FCPS Rock Creek School

Replacement and Final Site Selection

Design Meeting #9 - Notes

Meeting Date: 01 February 2018 | 9:30 AM | **Meeting Location:** FCPS Central Office, Board Room

BD-01

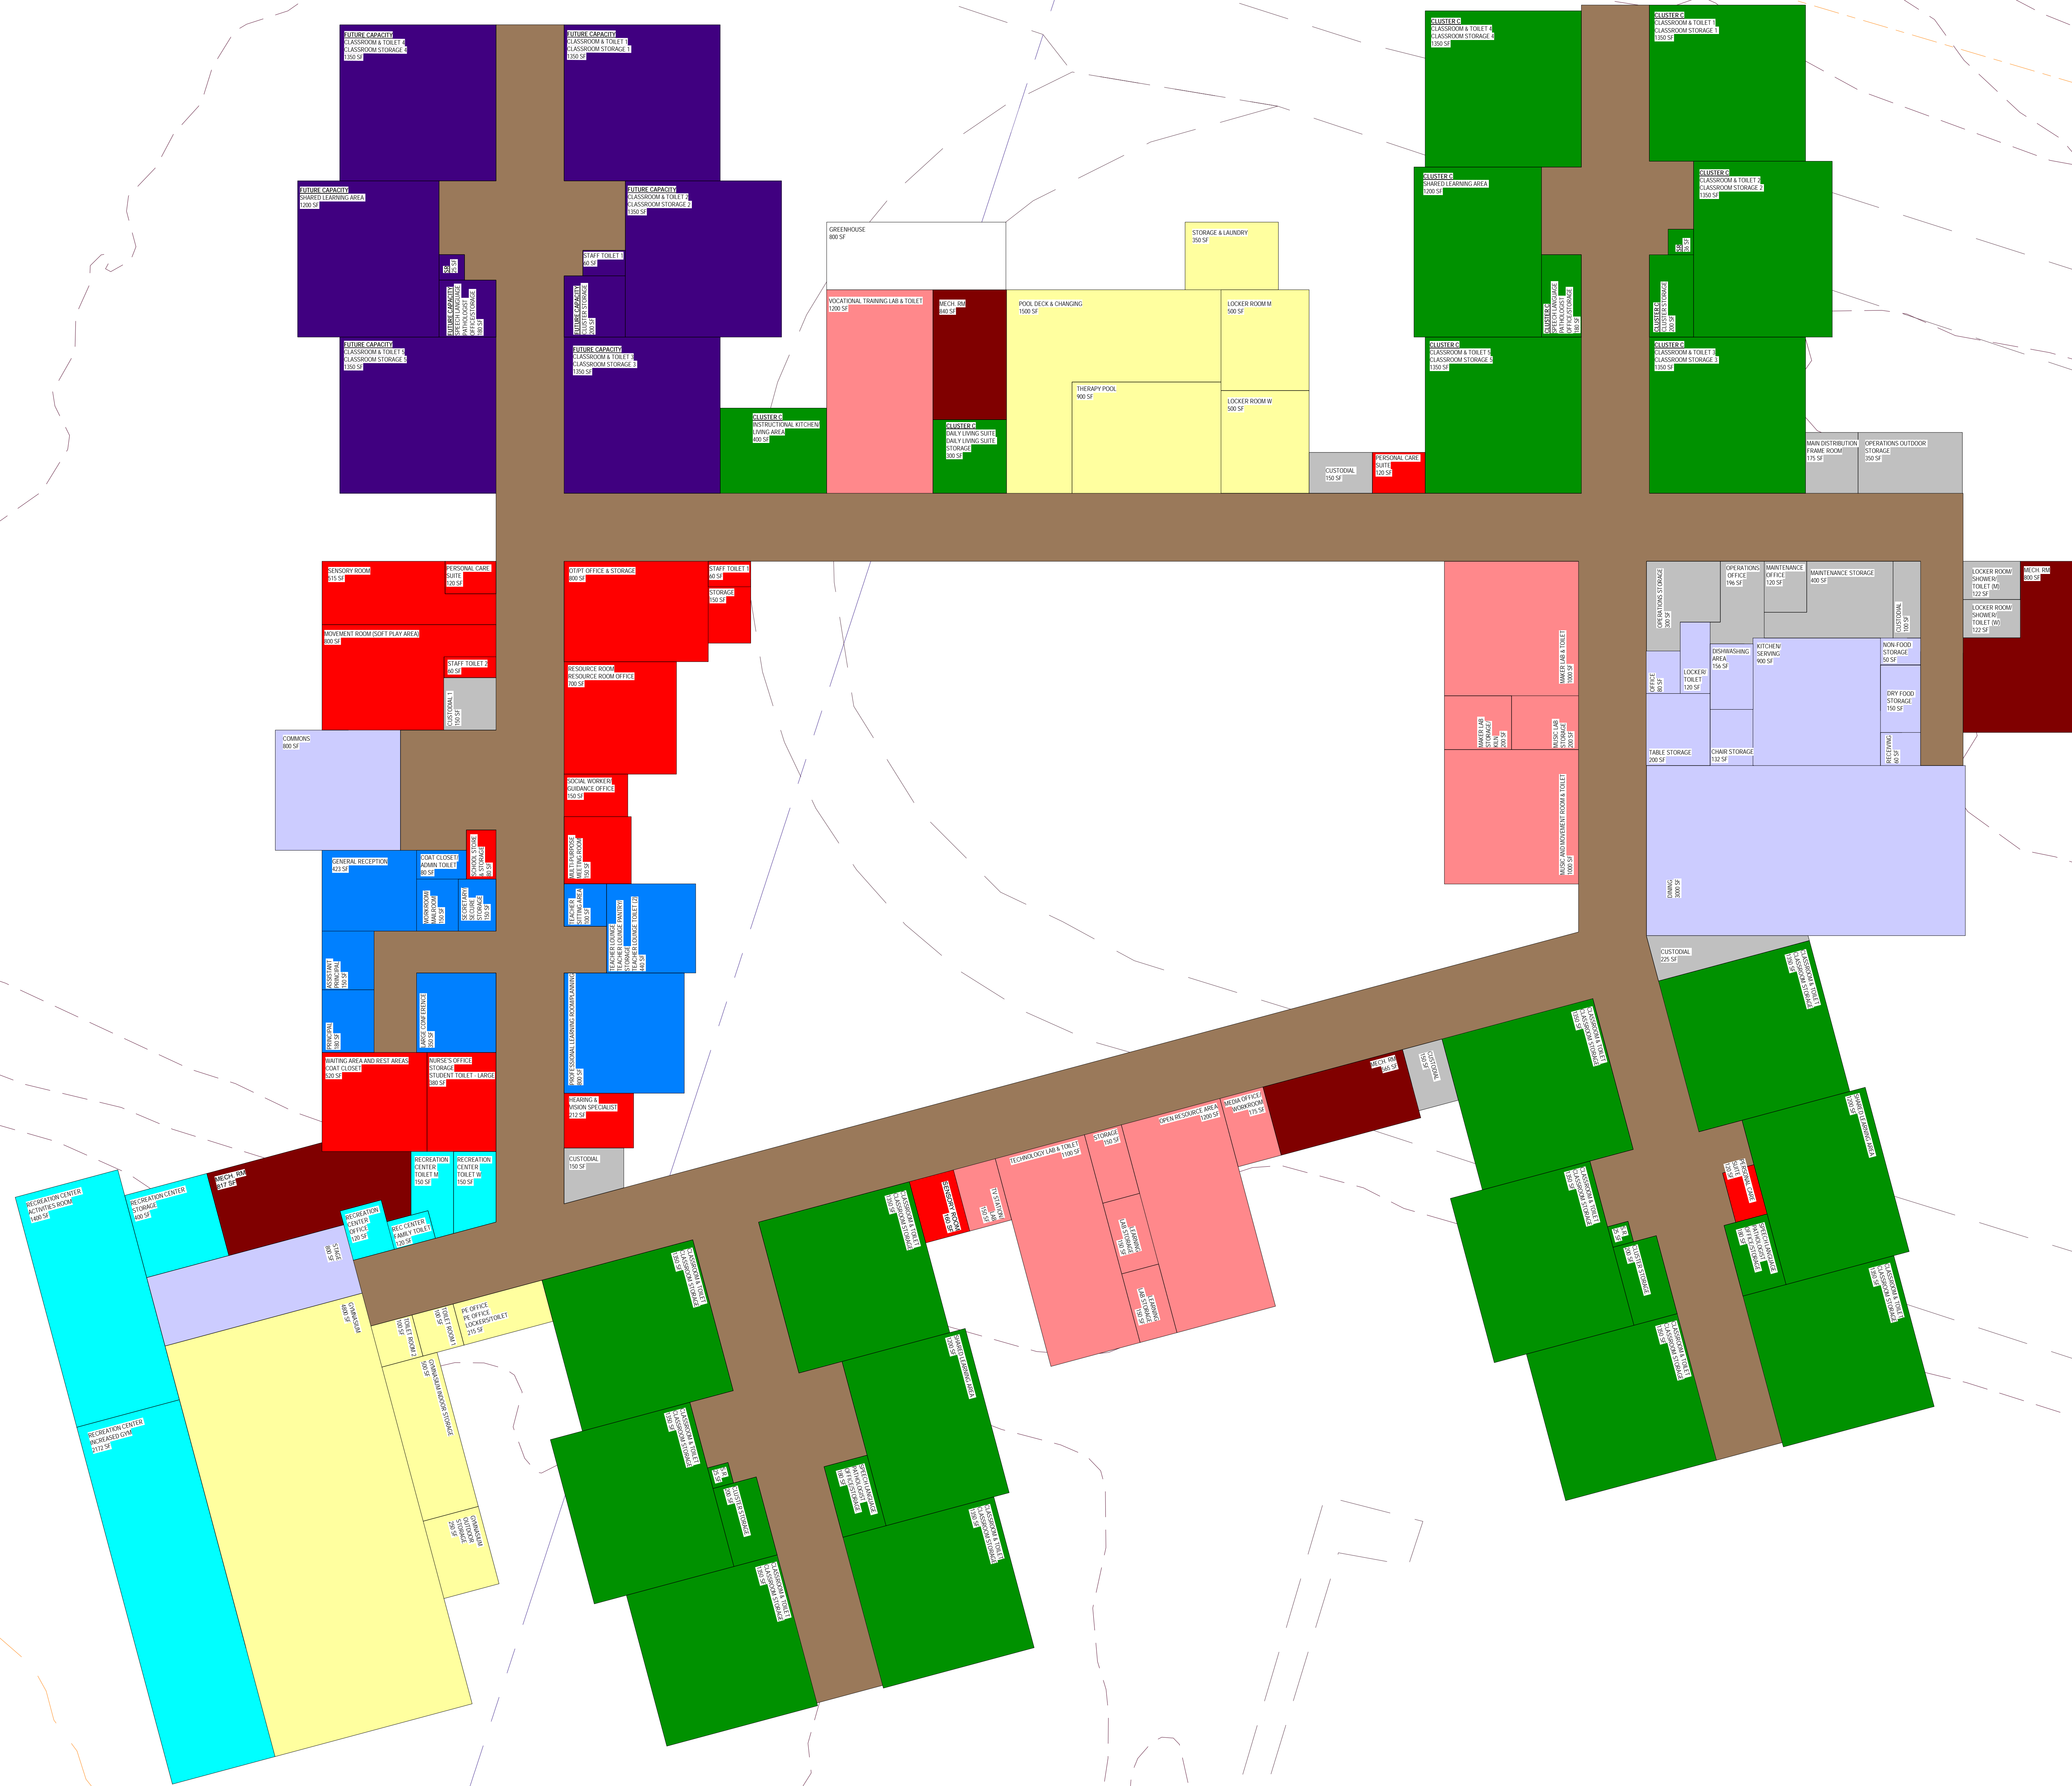
- d. For economy and ease of construction, the construction manager and FCPS would prefer an orthogonal layout for building in general – they would like to make the courtyard rectangular rather than having one side at an angle. The design team will try to get classroom pods identical and line up column lines straight across the building, even on both sides of the courtyard.

- e. The RCS cafeteria and kitchen should move to the southeast corner of the new building to keep loading dock near WMS dock.
- f. It was noted that the pool may want to be used by the local special needs community – it will be located at the northeast corner and this could be accomplished by using the existing Maryland Ave parking with a door directly to exterior from the pool area, therefore it would not need to be directly adjacent to the other Parks & Rec areas. This will also put it near the loading area for delivery of chemicals.

SP-01

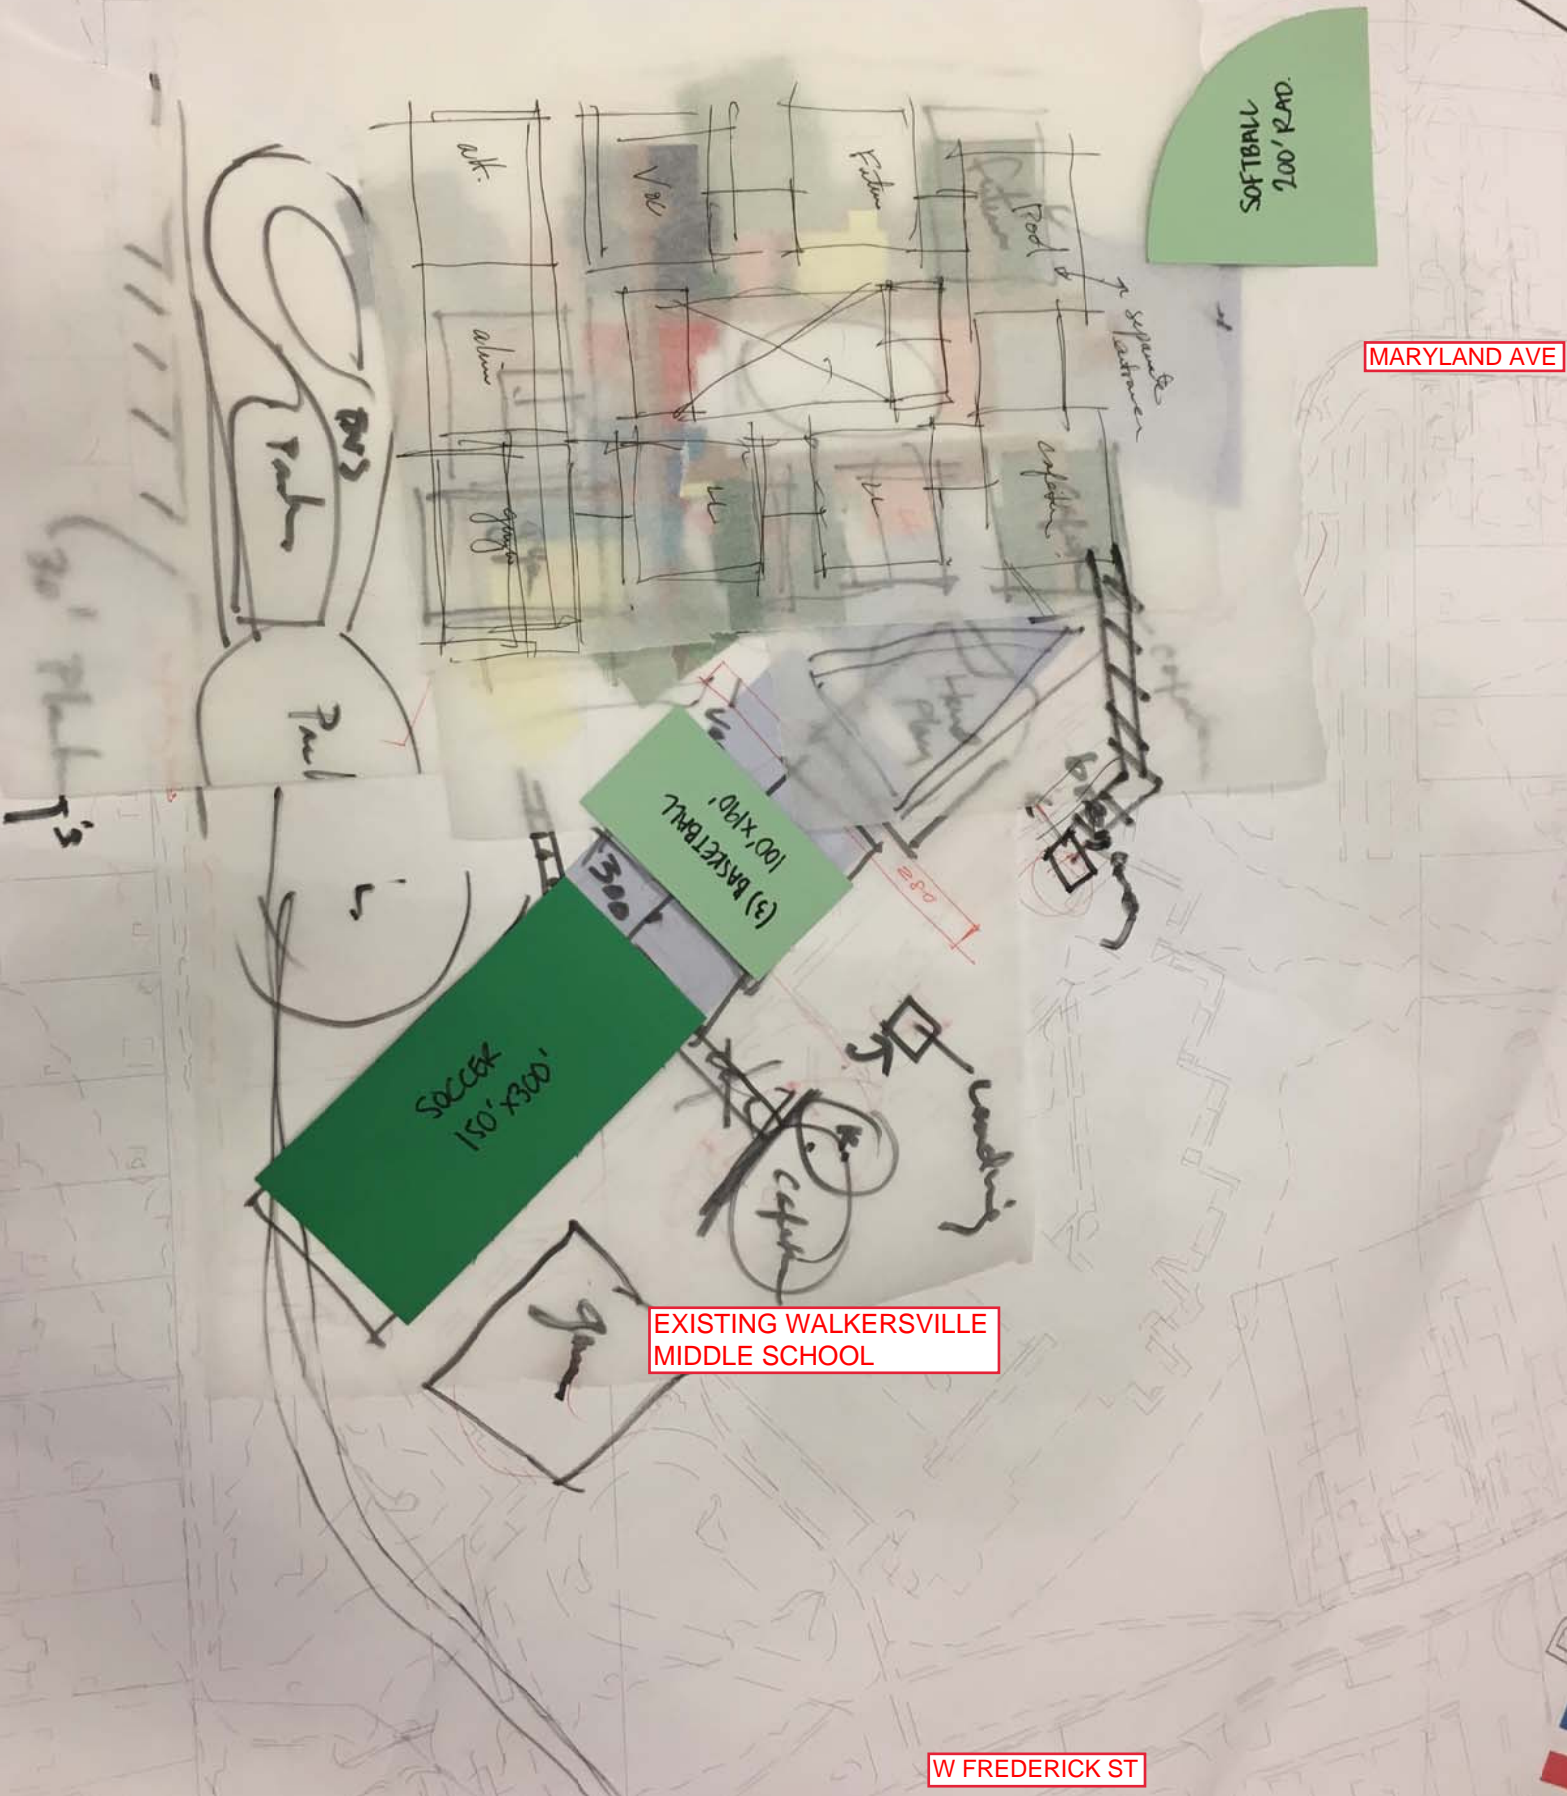
- a. Reviewed proposed location of building on site – see attached SP-01 diagram that was brought to the meeting for discussion. There was additional conversation about the balance between the MS fields and the meaningful connection between the two buildings. Beth expressed concern that the buildings are too far apart. The only way to pull the buildings closer together is by shifted some of the fields from what was agreed upon during the last meeting.

- 1. Per the Middle School Curriculum Director, typical Gym needs for a school with up to 5 PE classes are as follows: 1 group at Health, 1 group in Gym, plus at least 3 station areas outside, then they also need some areas for concurrent recess. These areas do not all have to be formal fields – for instance, 2 classes could use one soccer field simultaneously.

- 2. It was agreed that the proportions of the Rock Creek 150'x150' field could be adjusted. It could be triangular, rectangular, etc. as needed.
 - 3. A full-size softball field is not required at this school since there is no use of the fields by outside user groups. Several of the schools in the County are asking for removal of the softball backstops. A decision will be made later about whether or not a backstop is desired for PE classes to use for batting practice.

- 4. The connection between the two schools should either come from cafeteria or end of Art hallway – the Art hallway is really only good if we can move some of the existing parking out and make is so that the loading drive is all that would need to be crossed by students.

17-22 ROCK CREEK SCHOOL
DESIGN MEETING #9
FEBRUARY 1, 2018
SITE AND BUILDING BUBBLE DIAGRAM

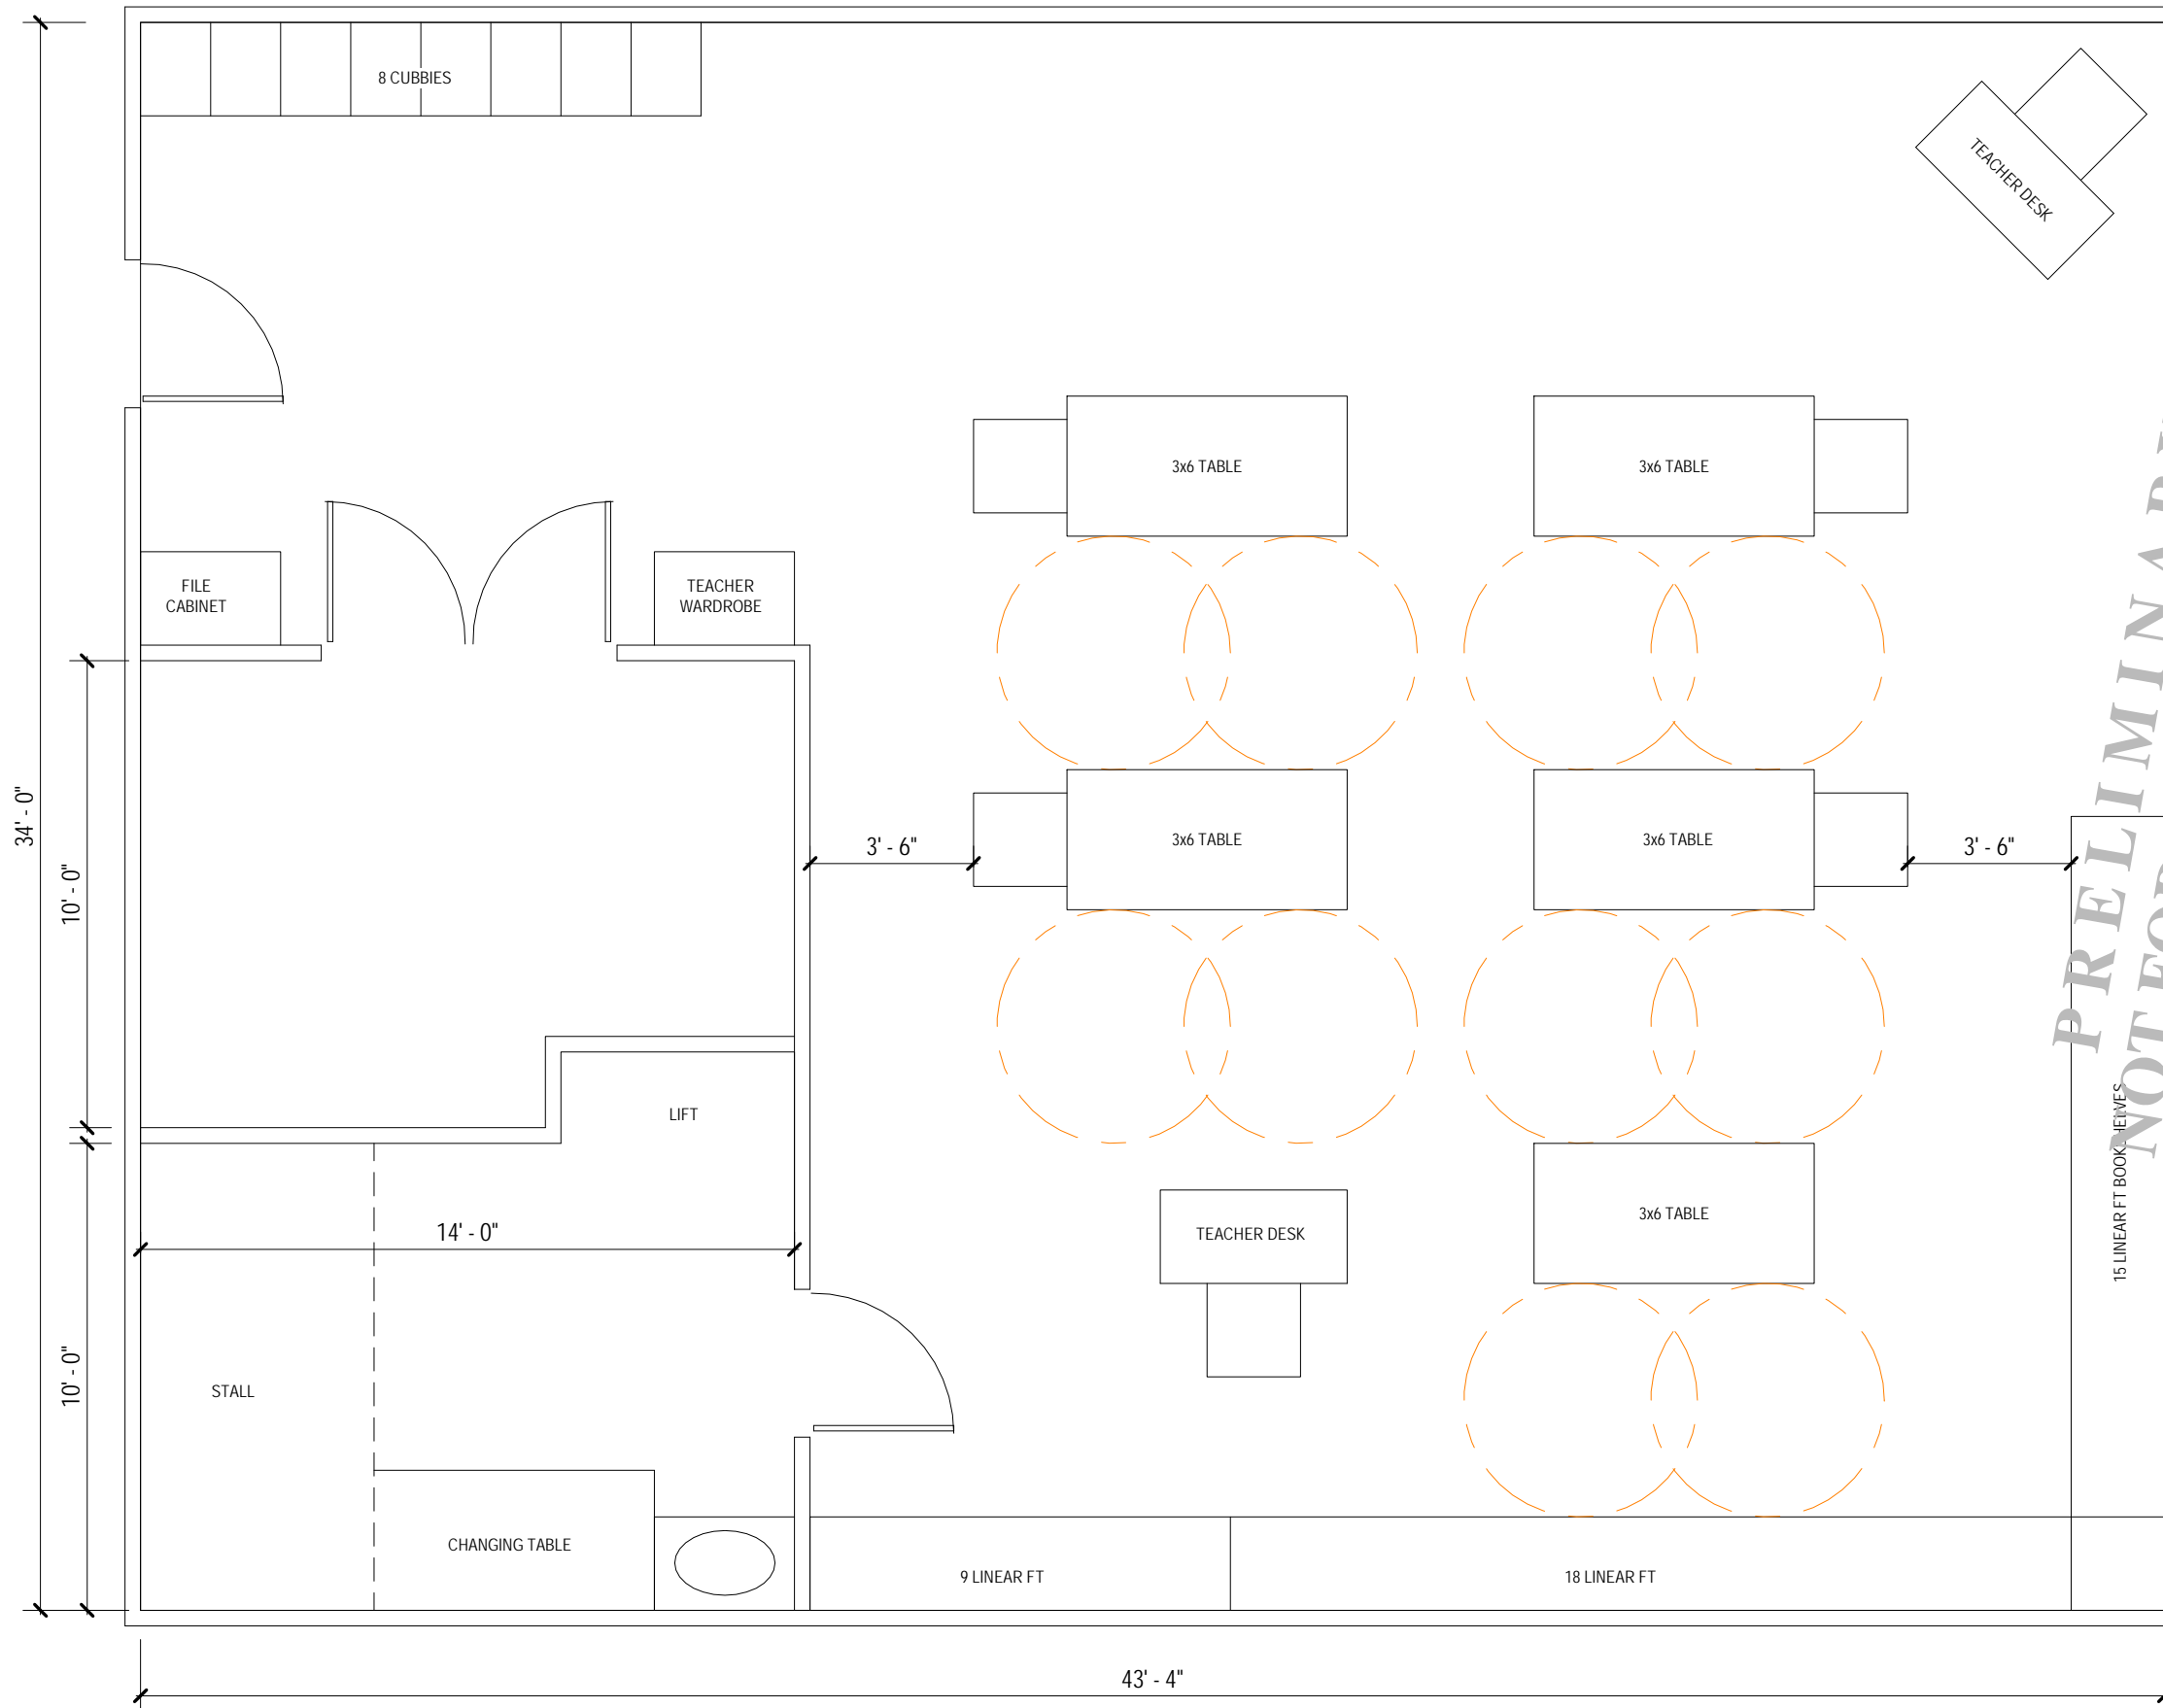
- i. A proposed new site/building diagram was developed to meet the site and building constraints. See the attached photo. The south side of the building will house the gym, elementary, and middle level pods. The north side will house the high school, future capacity, and alternative program areas.
